Re: Turkey Point Units 3 and 4
Docket Nos. 50-250 and 50-251
Response to NRC Request for Additional Information Regarding
Extended Power Uprate License Amendment Request No. 205 and
Nuclear Performance and Code Review (SNPB) Issues

RESPONSE TO NRC RAI REGARDING EPU LAR NO. 205
AND SNPB NUCLEAR PERFORMANCE AND CODE REVIEW ISSUES

Response to NRC Questions Regarding Boric Acid Precipitation

Figure 1 – Mass Calculations in SKBOR

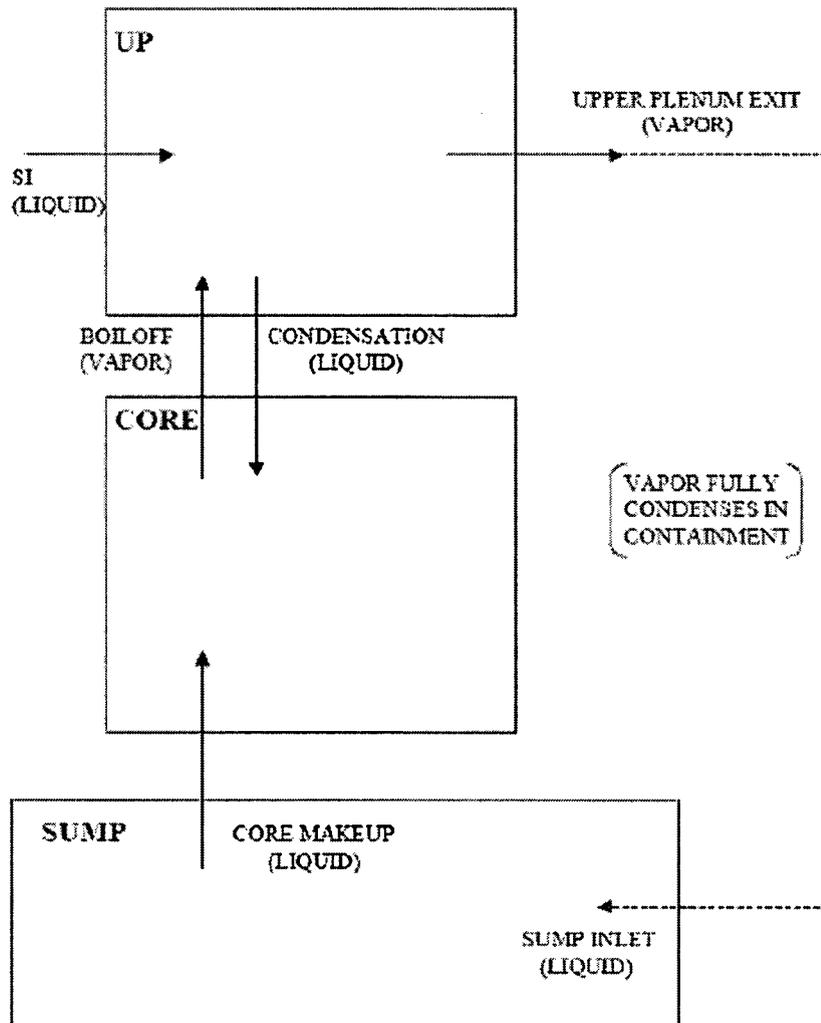
SNPB-3.1 Describe the primary input assumptions used in the analysis of post-accident boric acid precipitation and any uncertainty in the analysis results. Provide the basis for FPL's input assumption of 100% condensation efficiency, and include a discussion of containment vapor space water mass as a function of time.

A typical SKBOR calculation considers two volumes: one representing the effective vessel mixing volume (denoted as the CORE), and one representing the remaining system inventory (denoted as the SUMP). The CORE and SUMP are initially assumed to contain borated liquid at the system-average boric acid concentration. Vapor generated due to decay heat boiling exits the CORE with a boric acid concentration of zero (vapor is assumed to condense fully in containment) and is returned to the SUMP as unborated liquid (see additional discussion below). Borated liquid is added from the SUMP as required to keep the CORE volume full. In this way, the SUMP boric acid concentration gradually decreases, while the CORE boric acid concentration increases toward the boric acid solubility limit. The logic of the mass and boric acid calculations in SKBOR is shown in Figures 1 and 2.

Figure 5 – Core Region Boric Acid Concentrations for Various Containment Condensation Assumptions

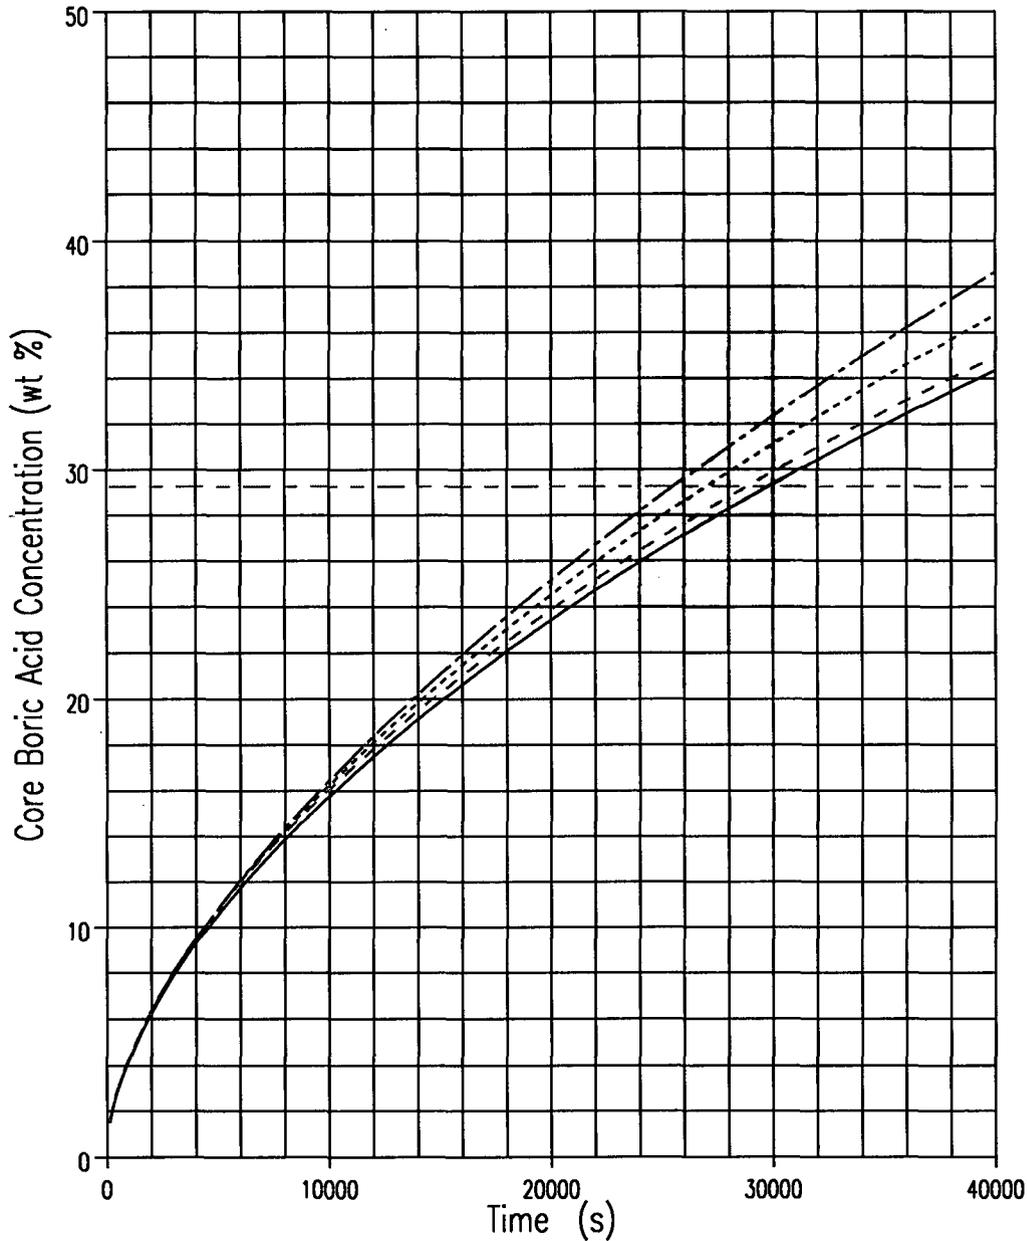
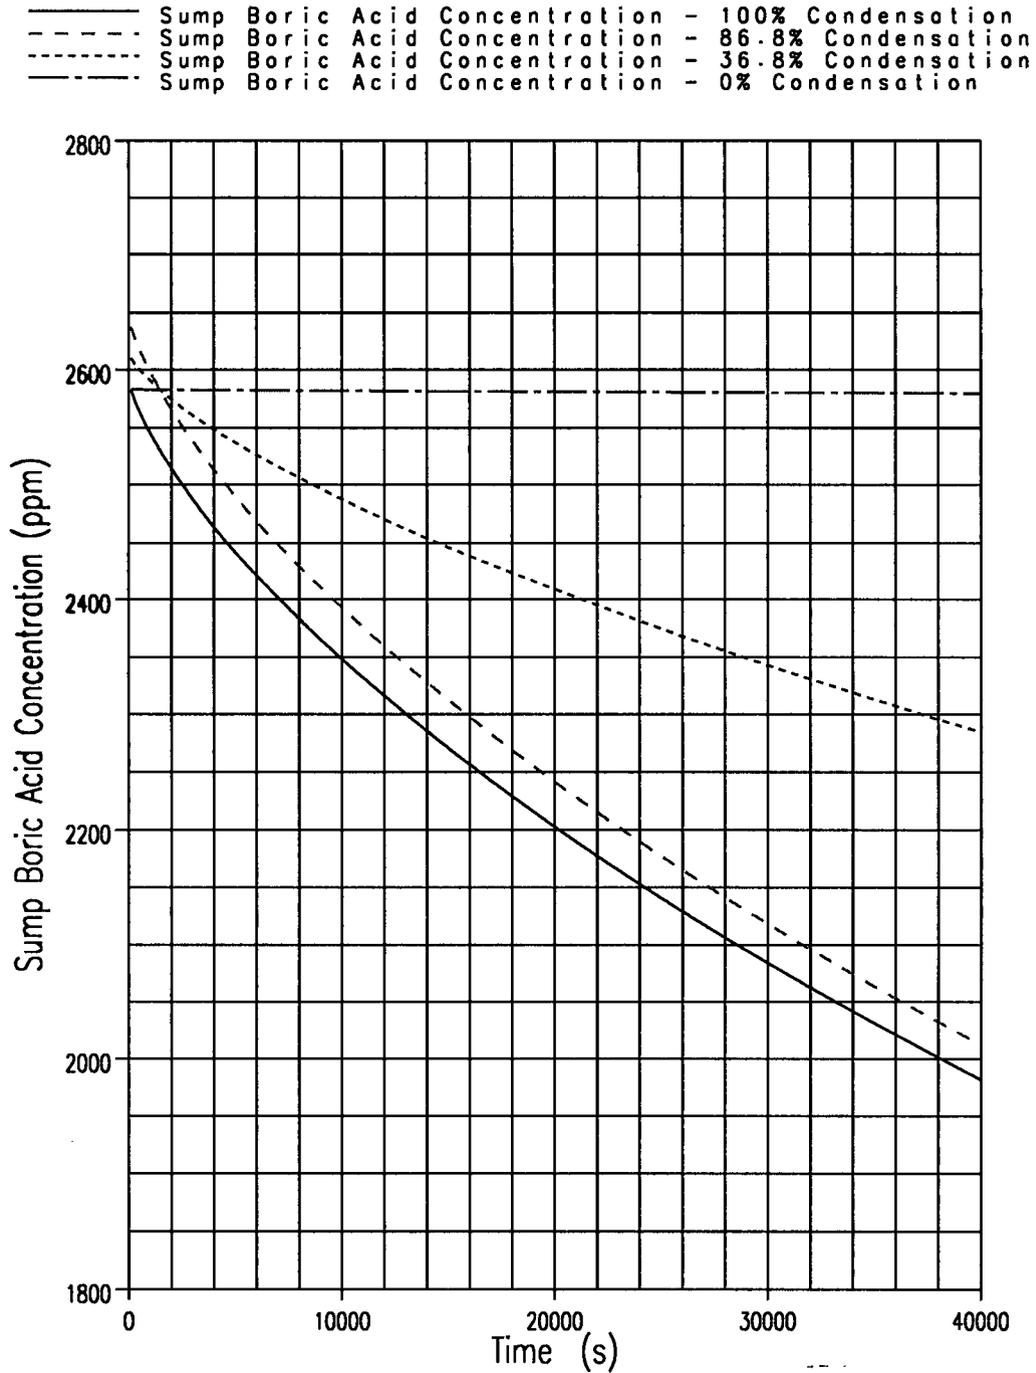
SNPB-3.2 Assess the sensitivity of the calculated hot leg switchover time to the condensation efficiency that is assumed for vapor released from the RCS to the containment atmosphere.

In order to assess the effect of more conservative assumptions regarding containment condensation, a sensitivity study was performed. The study used modified inputs to the SKBOR computer program to simulate various levels of sump dilution in the post-LOCA boric acid precipitation scenario and thus various efficiencies of containment condensation. For example, by adjusting the SKBOR initial conditions appropriately, a sump of nearly infinite mass can be modeled. This case would show negligible sump dilution throughout the transient as the sump is so large that condensing steam returning to the sump would have an insignificant effect on the sump boric acid concentration. Consequently, the core boric acid buildup calculation would not benefit from any reduction in the sump boric acid concentration. This case is represented in Table 1 as the 0% Containment Condensation case. Using similar methods, the containment sump initial conditions can be adjusted to study the effects of other levels of containment condensation. Tables 1 and 2 contain the results of calculations using a range of assumptions for containment condensation. As demonstrated in Table 1, the most conservative assumption of 0% containment condensation results in a 1.19 hour reduction on the time to reach the boric acid precipitation point from the LAR base case (which assumes 100% containment condensation). Table 2 shows that even with the most conservative containment condensation assumption of 0% there is still margin to the solubility limit at atmospheric conditions at the HLSO time of 5.5. hours. Figure 5 shows the boric acid concentration versus time for various containment condensation assumptions. Figure 6 shows the boric acid concentration in the containment sump versus time for the various containment condensation assumptions. Figure 7 shows the core average and core exit void fraction versus time. Further discussion of the void fraction correlation utilized in the boric acid concentration calculations is contained in Reference 2.

Figure 8 – Core Support Region Liquid Temperature and Saturation Temperature

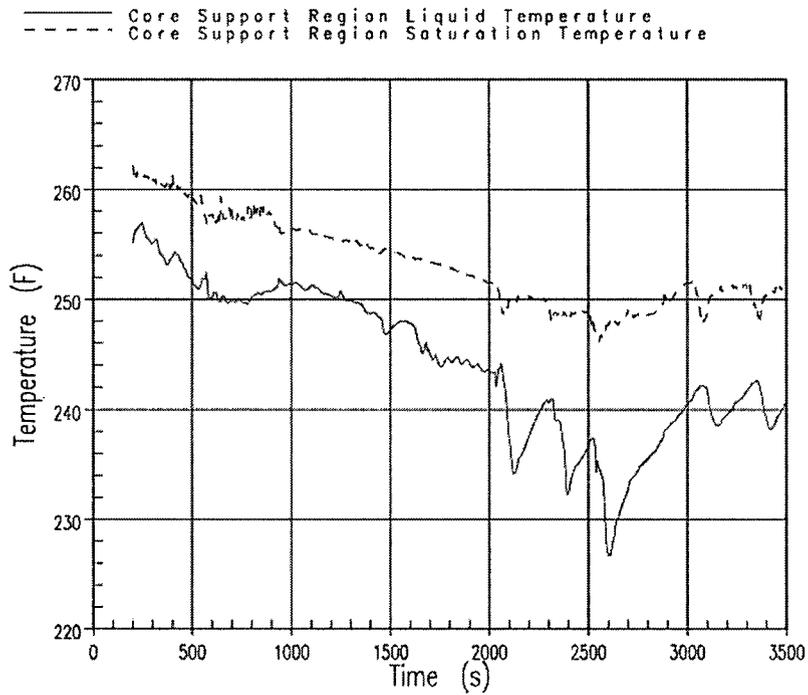
SNPB-3.3 Provide additional description of the mixing model in the lower plenum for the boric acid precipitation analysis. Show that when conservative values are used for ECCS fluid temperature and flowrate during the injection phase of a LOCA, lower plenum fluid temperature remains above the point at which boric acid precipitation could occur.

In the period after core quench but prior to sump recirculation for the cold leg break scenario with low natural circulation flow through the reactor vessel, the temperature in the lower plenum is expected to be near the saturation temperature. This expectation is confirmed by calculations using the WCOBRA/TRAC thermal-hydraulic code. Boundary/initial conditions include minimum safety injection flow at a temperature of 69.5 °F until the emergency core cooling system suction is realigned for sump recirculation at 45 minutes into the event. Figure 8 and Figure 9, respectively, show the upper (core support) lower plenum and lower head liquid temperatures and saturation temperatures. Figure 10 shows the pumped ECCS mass flow rate on each of the intact loops as well as the temperature of the coolant (Figure 11).
